SUMMARY OF CONCERNS IN RELATION TO THE PROPOSED NORTHCONNEX TUNNEL

This is an objection to many aspects of the proposed NorthConnex tunnel.

SECTION A: THE CONNECTIVITY OF NORTHCONNEX SOUTHERN VENTILATION FACILITY AT THE SOUTHERN INTERCHANGE, THE SOUTHBOUND TUNNEL IN PARTICULAR

MOTORWAY OPERATIONS COMPLEX - SOUTHERN VENTILATION FACILITY - SECTIONS
M1-M2-5000-DR-JD-0525

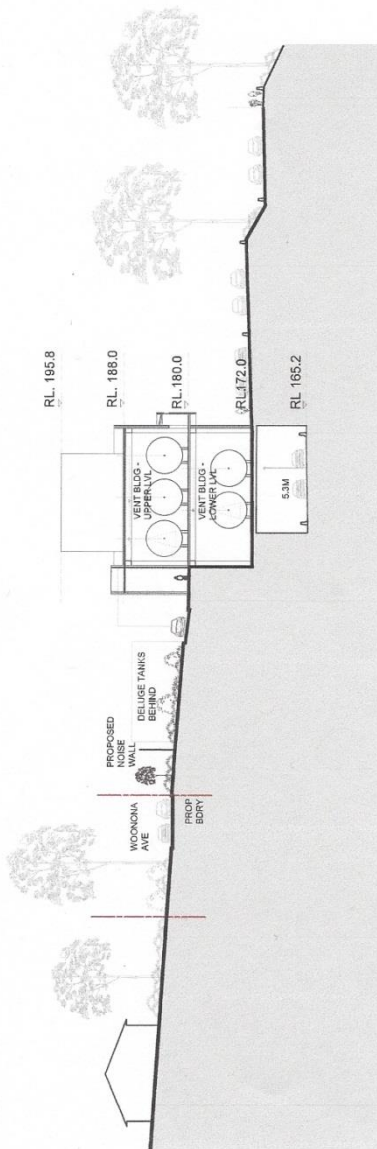
5. *EIS Volume 4, Technical working papers - Urban Design, 6.0 Operational Ancillary Facilities*
EIS Page 99 there is the diagram "Motorway Operations Complex – Southern Ventilation Facility – sections. *Page 10 below* The diagram has the cryptic label "Connection to tunnel TBC". What does TBC stand for? To be considered? Why is tunnel singular? Which tunnel is the diagram referring to northbound or southbound? There is no diagram showing any connection from the Southern Interchange ventilation facility to either the northbound or the southbound tunnel in any way AND YET

- Diagrams need to be provided showing the inter-relation between the shaft, the ventilation outlet and the motorway operations centre with a clear description of what is to be constructed and how it will operate.
- The community needs irrefutable evidence that the polluted air from the southbound tunnel exit portals will not be allowed to flow like an invisible sewer through West Pennant Hills, North Rocks, Carlingford and Beecroft.

M1-M2-5000-DR-UD-0550
NORTHERN VENTILATION FACILITY - CROSS SECTIONS

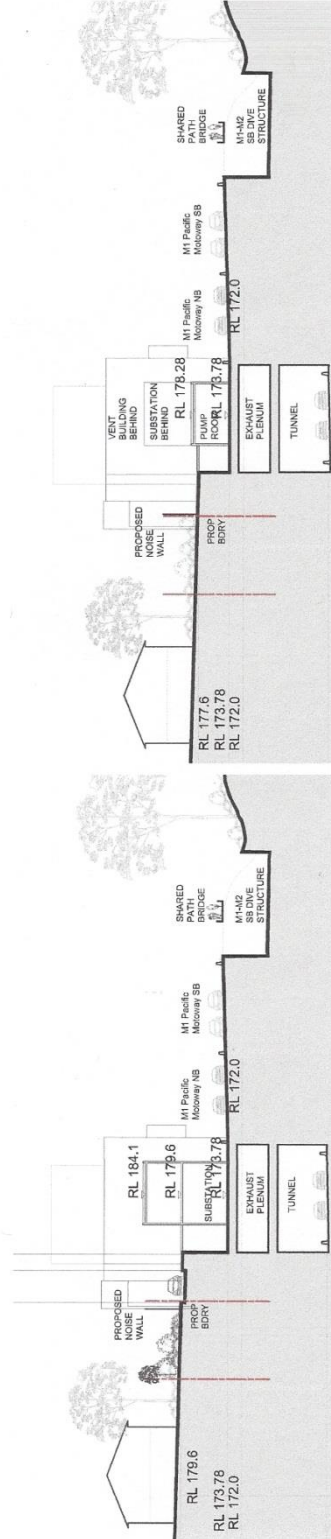
EIS page 135 *Page 11 below* there is a very explicit diagram showing the *Northern Ventilation Facility – cross section*.

Why are there no comparable diagrams for the Southern Interchange and the Southern Ventilation facility?

MOTORWAY OPERATIONS COMPLEX - SOUTHERN VENTILATION FACILITY - SITE SECTION 1-1
M1-M2-5000-DR-UD-0713

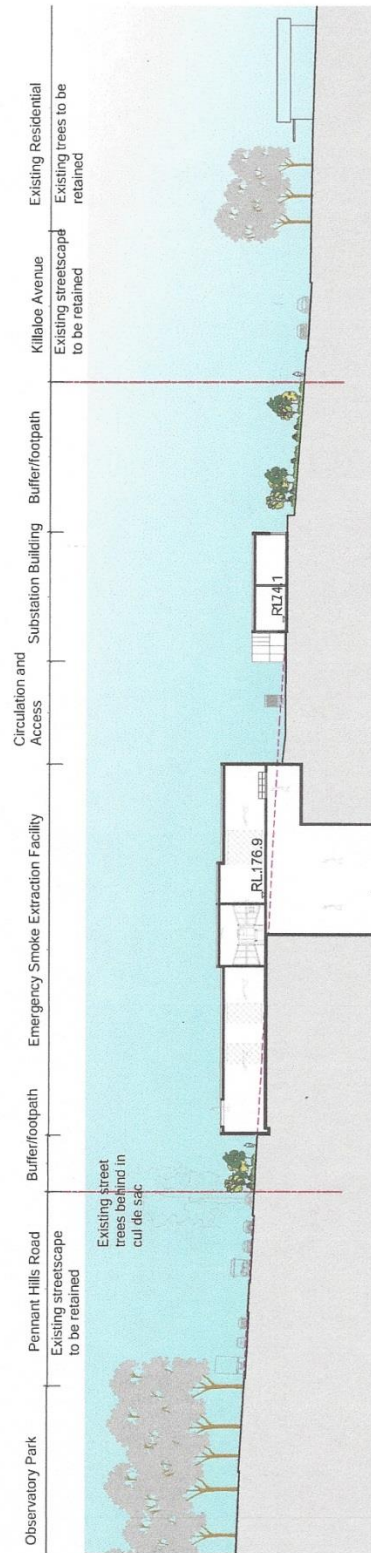
6. *EIS Volume 4, Technical working papers Urban Design, 8.0 Landscape Design*
EIS Page 176 is the diagram "Motorway Operations Complex – Southern Ventilation Facility – Site 1-1". *Page 13 below* The diagram does not show any connection to either the northbound or southbound tunnel. In the same Landscape Design section, EIS Page 182 is the diagram "Wilson Road Tunnel Support Facility –Section" *Page 14 below* which clearly shows the connection to the tunnels. In the same Landscape Design section, EIS Page 189 is the diagram "Northern Ventilation Facility – Landscape Concept Section". *Page 15 below* This also clearly shows the connection to the tunnels.
